## ADDENDUM

Project:	Iqaluit West 40 Landfill Site Access Improvements	Addendum No.: 3
		4 Pages
		April 29, 2019
		820973-0066(3.0)

Trail Area Deposit Map, red areas are available for the contractor to take fill material. The blue area is reserved for another project. The City can meet with the successful bidder to show in more detail what the limits are.

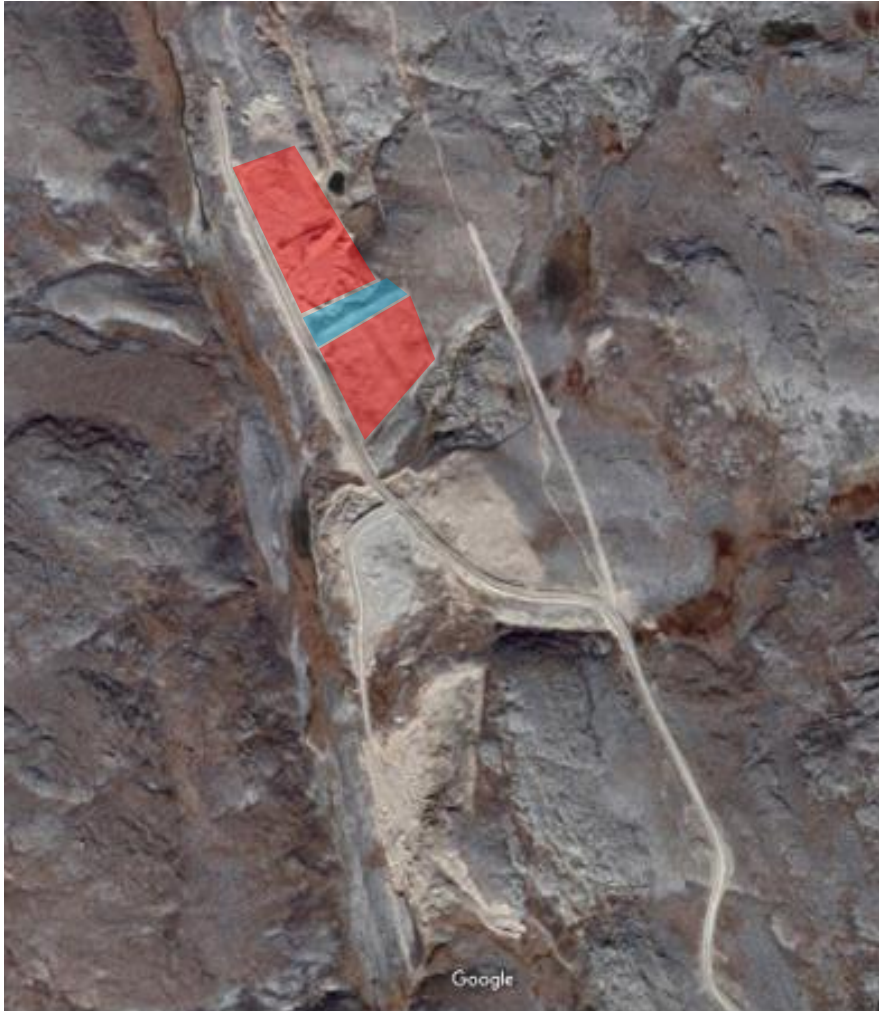
<b>1.1.5</b>	<b>Q5:</b> As per the image attached image, please identify the locations that contain the required aggregate to substantially complete the demands of this project. Also, please identify the location of the area that is reserved for a separate project. <b>A5:</b> The aggregate supplied from the Trail Area Deposit is intended to be used as general fill. Please see the marked up aerial photo graph showing the available areas.	
<b>1.1.6</b>	<b>Q6:</b> Will royalties be applied to the material extracted from the Trail Area Deposit? If so at what rate? <b>A6:</b> Royalties will not be applied to the material extracted from the Trail Area Deposit used for this project.
